DEVELOPMENT REVIEW BOARD

Planning Dept. - Major Case Comments

Project Number: PR-2021-004138

Application Number: SD-2021-00151 – PRELIMINARY PLAT
Project Name: Montage Unit 6

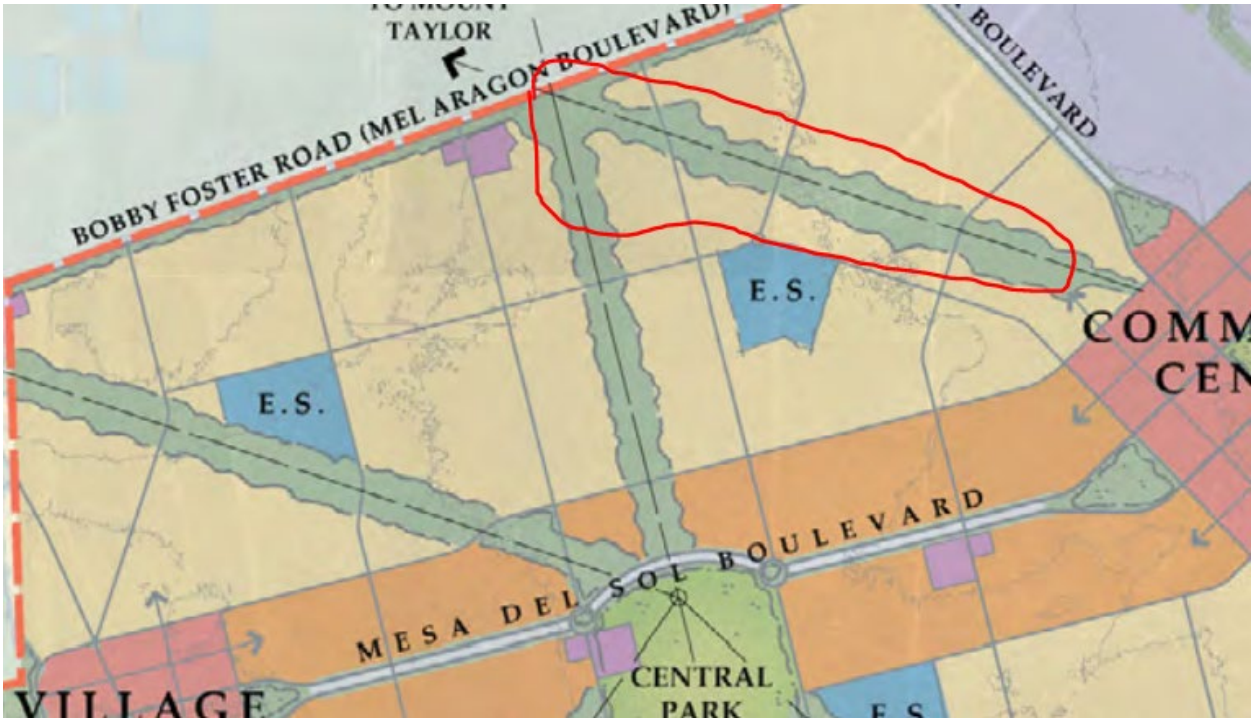
1. We need an Archaeological Certificate that's issued with a Certificate of Approval or a Certificate of No Effect before the DRB can approve the Plat. See IDO 6-5(A)(1).
2. The Preliminary Plat has "lot size varies" on a number of lots, but then has the acreage as well on the lots. No lot dimensions are depicted for the individual lots. Please clarify the lot sizes.
3. ~~The Mesa del Sol Master Plan shows a layout of linear parks and drainage basins to be developed as a system. It is time for the MdS Master developer to help provide this park/drainage infrastructure with the associated commitments for each individual subdivision. Please provide a plan for how the linear park/drainage (see area circled in red) will be accomplished along this corridor prior to preliminary plat approval.~~
